Subject: Crystal River Unit 3
Docket No. 50-302
Operating License No. DPR-72
Inservice Testing (IST) of Pump and Valves

Crystal River Unit 3 (CR-3)

Responses to NRC Concerning

Inservice Testing of Pump and Valves

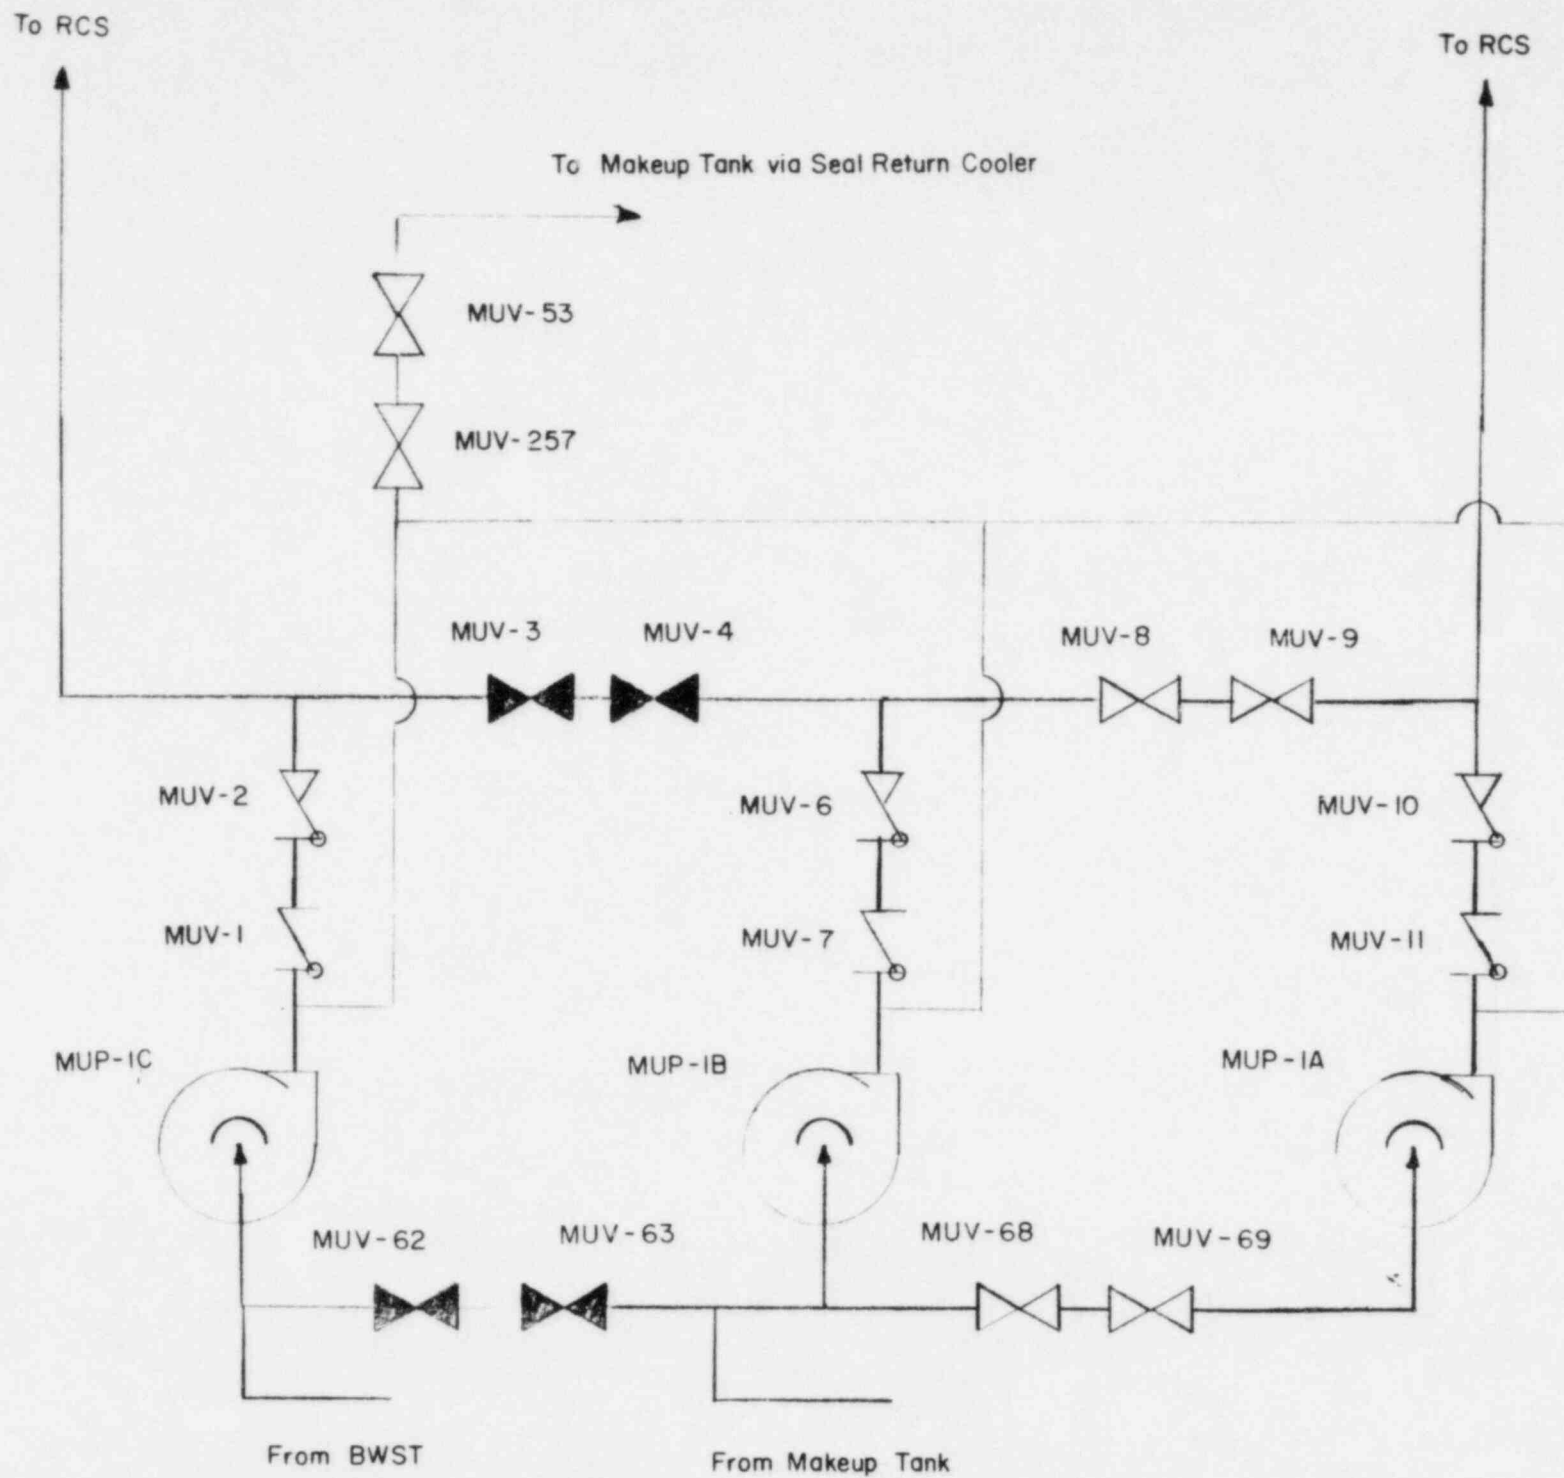
- Q6. The licensee has requested specific relief from the exercising requirements of Section XI for valves MUV-53 and 257, makeup pump minimum flow recirculation valves, and has proposed to exercise these valves at cold shutdown. The licensee states that stroking of these valves during normal plant operation would interrupt minimum recirculation flow on the running makeup pump. Should the valve fail in the closed position, damage would result to the makeup (high pressure injection) pump. We do not agree with the licensee's basis and, therefore, conclude that relief should not be granted. The licensee has stated that pump damage could result if the valve fails closed on the running pump. However, we have concluded that operation of the pumps could be shifted and testing conducted per Section XI.

- R6. The minimum flow path, from the makeup pumps to the makeup tank is through series valves MUV-53 and MUV-257. Closure of either valve would isolate the common header for all three makeup pumps to the minimum recirculation flow path. Isolation of this flow path would result in pump damage. Florida Power Corporation, therefore, requests that the relief be granted. The attached system drawing is provided for information.

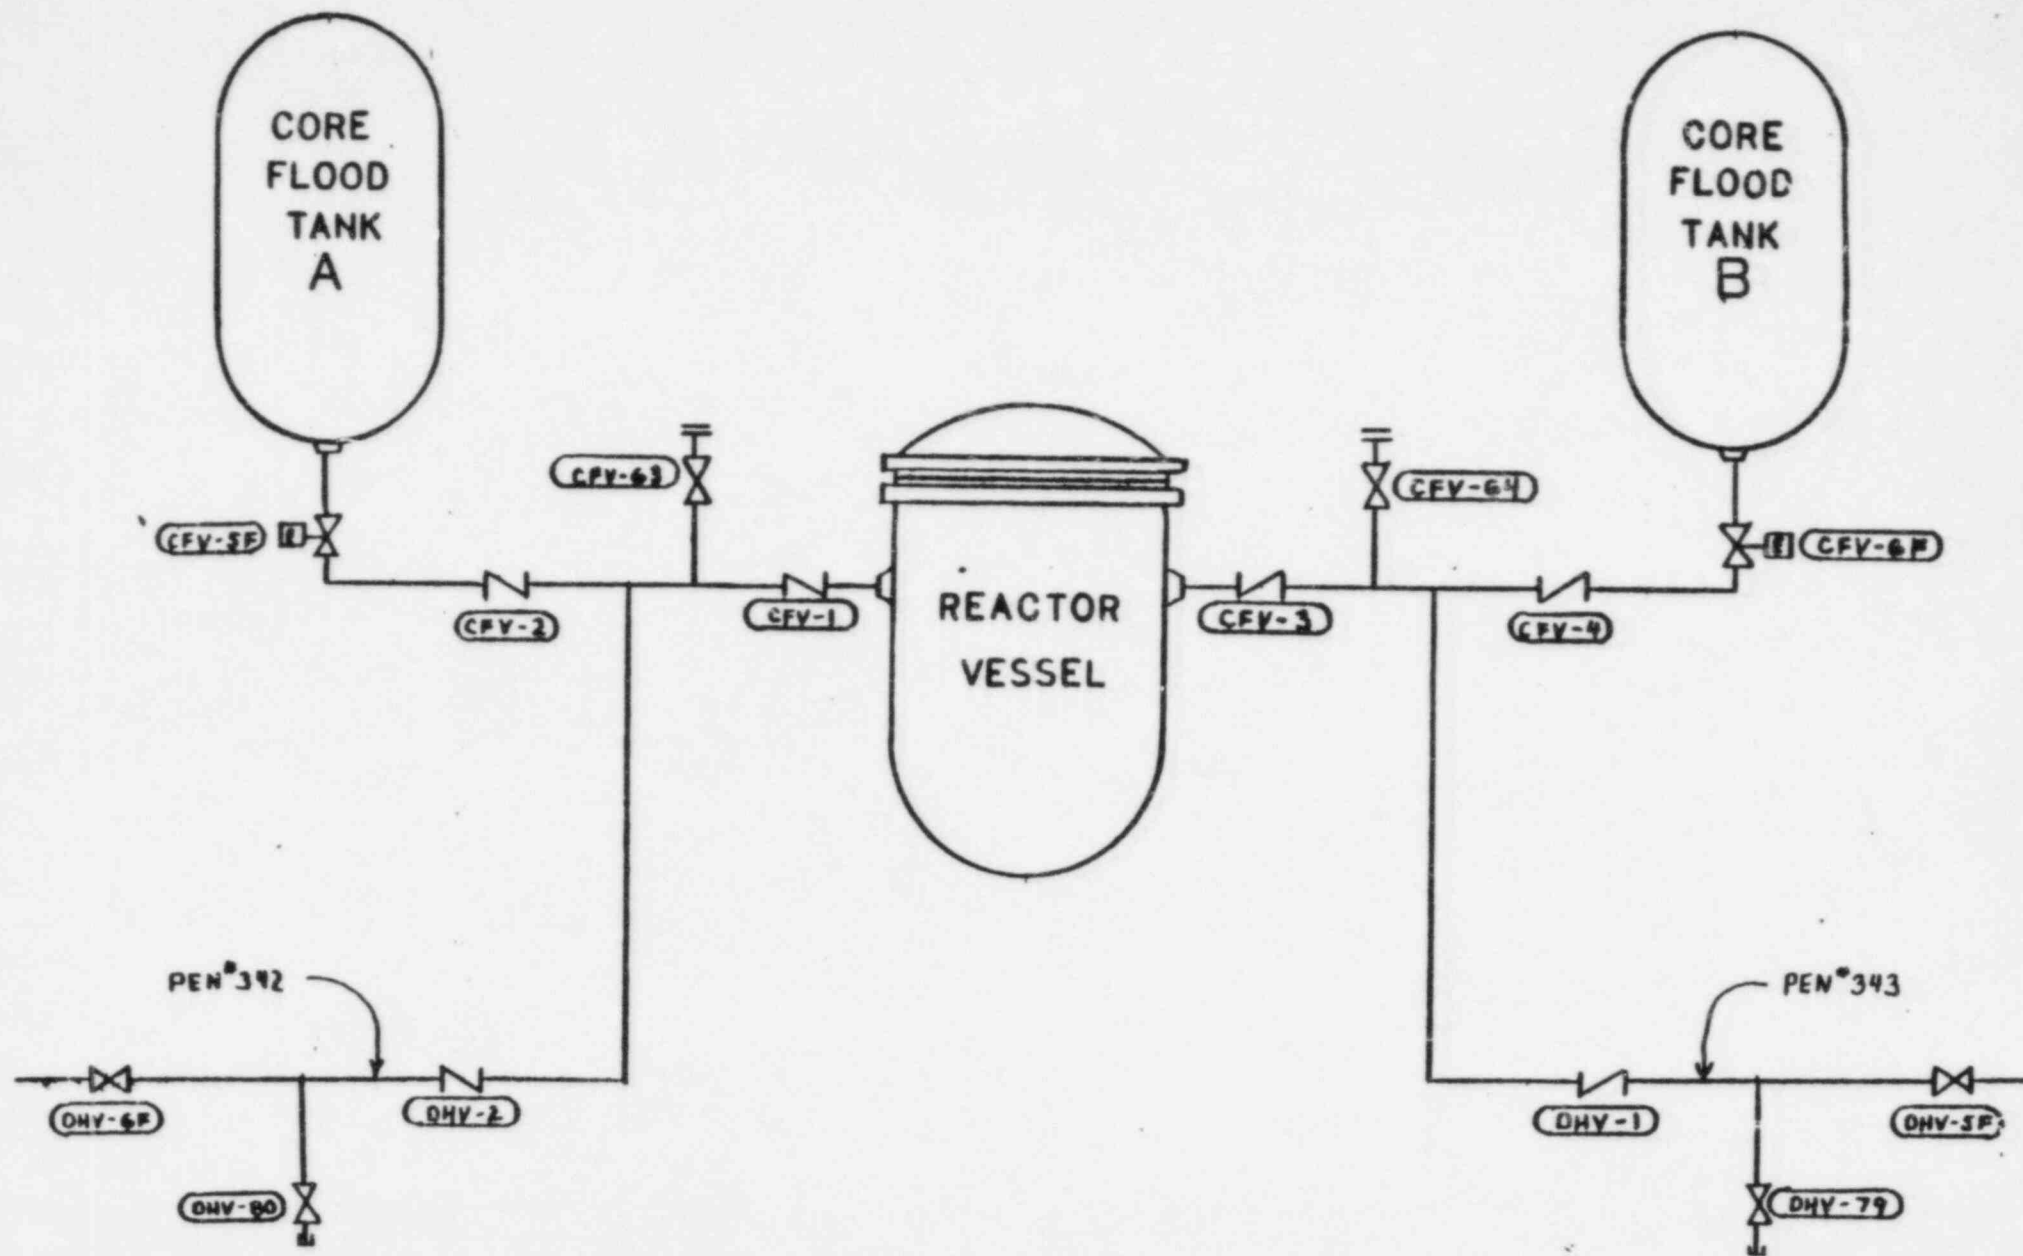
Q9. The licensee requested specific relief from the Section XI quarterly exercising requirements for valves CFV-2 and 4. The licensee has proposed to partial stroke these valves at refueling outages. It is our position that partial stroking does not provide adequate assurance of valve operability, and that the valves should be either exercised per the Code or internally inspected on a refueling outage frequency.

(b) Function: These valves are in the flow path from the core flood tanks to the reactor coolant system (RCS). These valves provide passive isolation from the higher pressure RCS to the low pressure core flood tanks and the decay heat system and between the core flood tanks and the decay heat system. See the attached sketch for the layout of the valves.
